Addendum No. 1

Subject: BLANKENBURG ELEMENTARY SCHOOL
NEW CAFETERIA AND KITCHEN
SDP CONTRACT NOS. B-060 C, B-061, B-062, B-063 C OF 2020/21

Location: BLANKENBURG ELEMENTARY SCHOOL
4600 W. GIRARD AVENUE,
PHILADELPHIA, PA 19131

This Addendum, ***dated 26th of February, 2021***, shall modify and become part of the Contract Documents for the work of this project. Any items not mentioned herein, or affected by, shall be performed strictly in accordance with the original documents.

DRAWING NO.
FA101
SHEET 39 OF 44

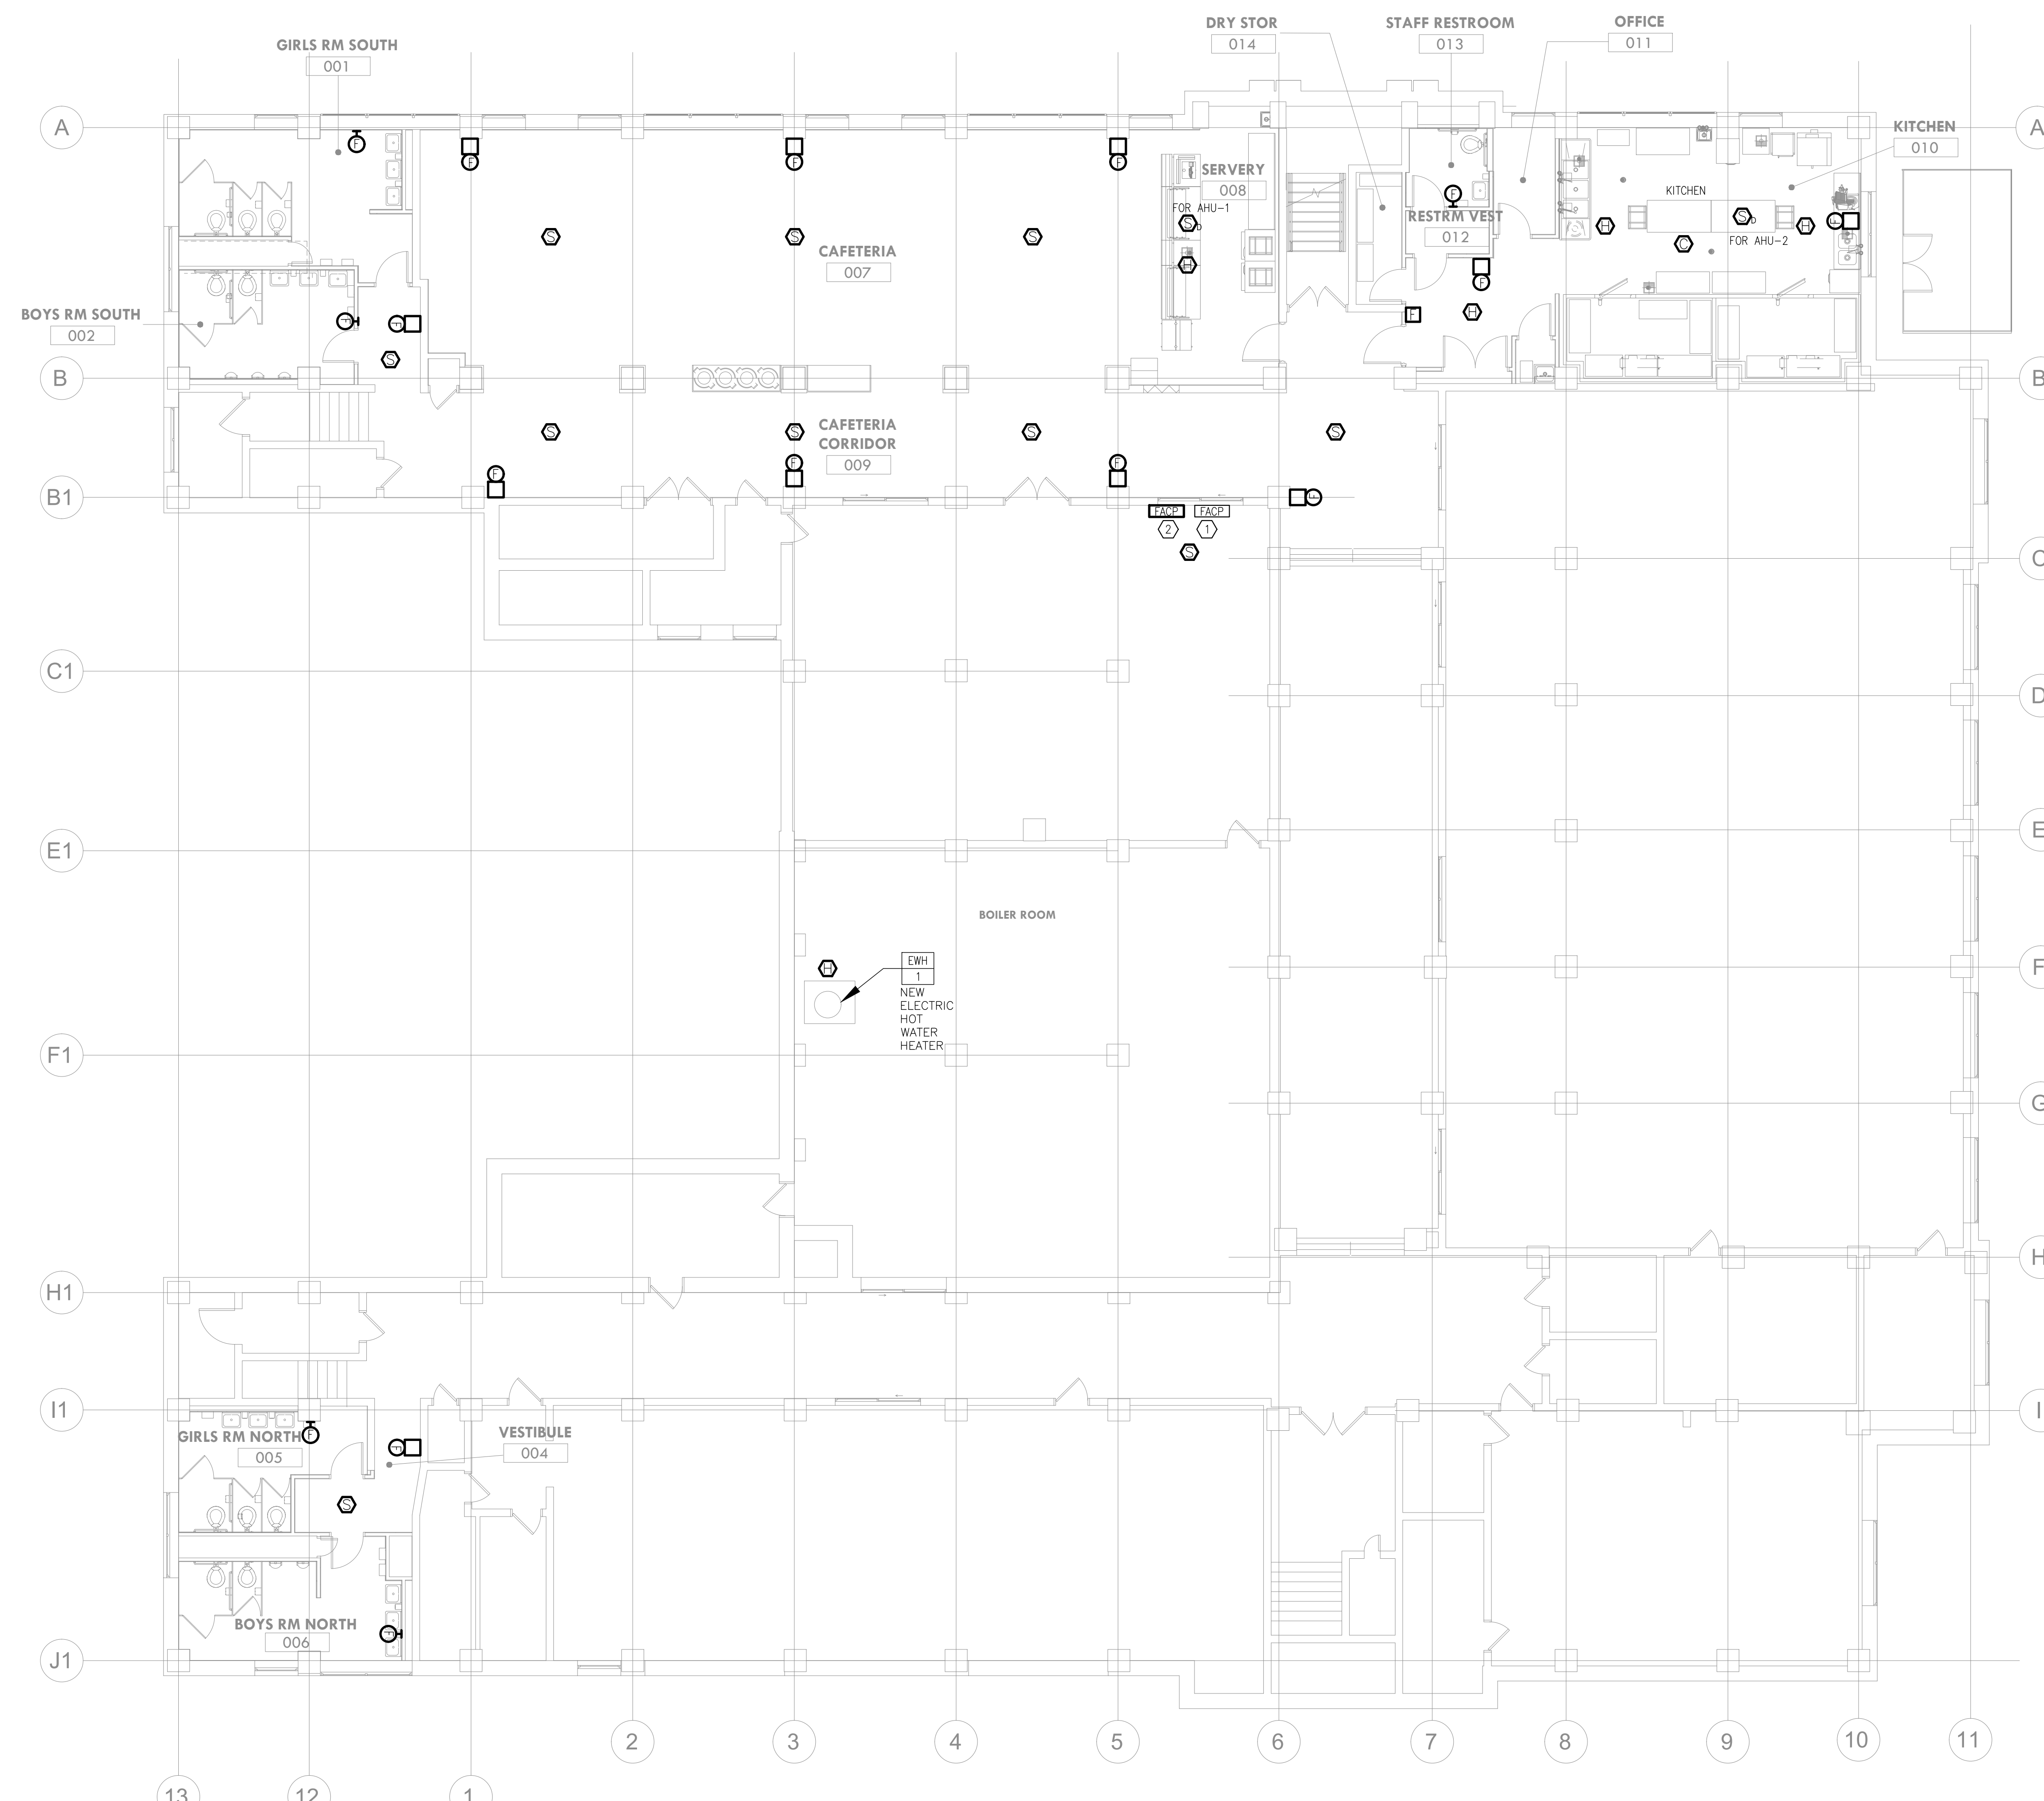
- e. Drawing FA101:
 - i. Revised fire alarm drawing.
 - f. Drawing FA102:
 - i. Revised fire alarm drawing.
5. Revised Drawings by Narrative:

6. There are initiating device symbols on the fire alarm floor plans that are not indicated in the symbols list on FA000. It is unclear what type of audible initiating device should be provided (speaker? Horn?). Does the existing system have voice capability or not? Please provide an updated symbols list that reflects the existing system and includes all symbols shown on the plans.

- a. The audible device shall be a speaker. Existing system does not have voice capability. Symbol list has been updated and revised drawings and specifications attached.

DRAWING NO.
FA102
SHEET 44 OF 44

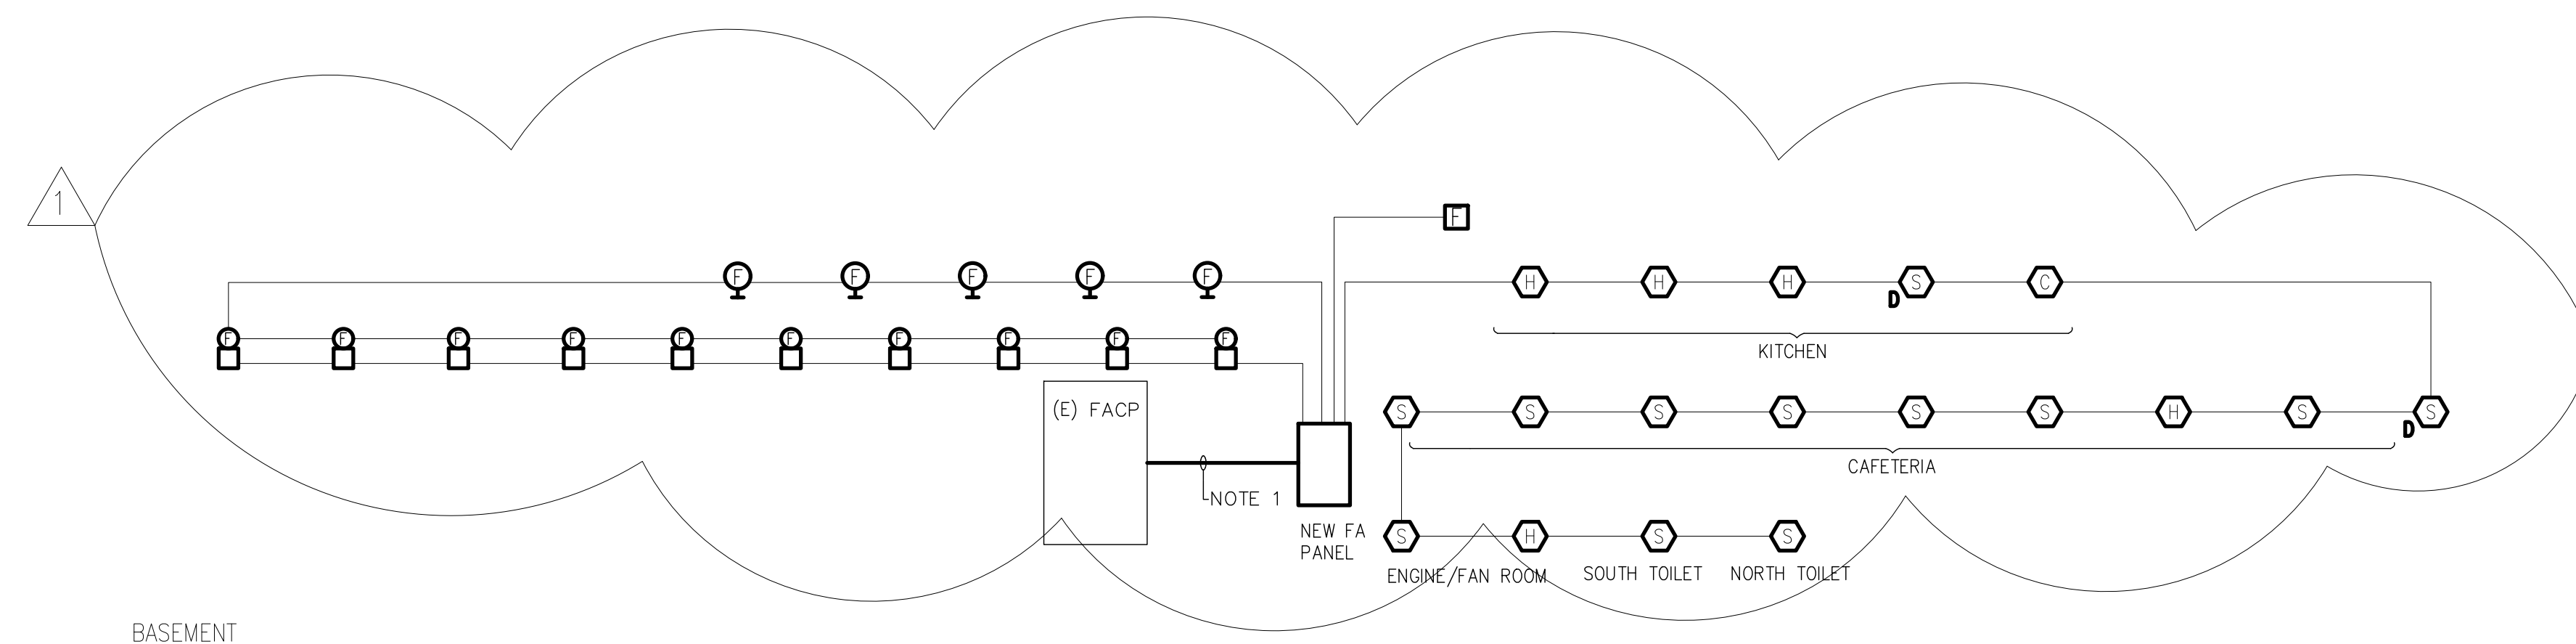
- a. Provide DACT for the new fire alarm installation.
8. Please confirm general note 3 on FA000 ("provide a new addressable fire alarm system") is **not** applicable to this project, as the fire alarm plans indicate that we are connecting to an existing fire alarm system.

- a. The new Fire alarm system shall be a voice enabled addressable system. Refer to attached revised drawings (FA000, FA100, FA102) and specifications.

NOTE:
1. PROVIDE NEW FIRE ALARM PANEL AND CROSS-TRIP TO EXISTING FACP. PROVIDE ALL NECESSARY HARDWARE & SOFTWARE FOR CROSS-TRIP OF EXISTING FIRE ALARM PANEL TO NEW FIRE ALARM PANEL.
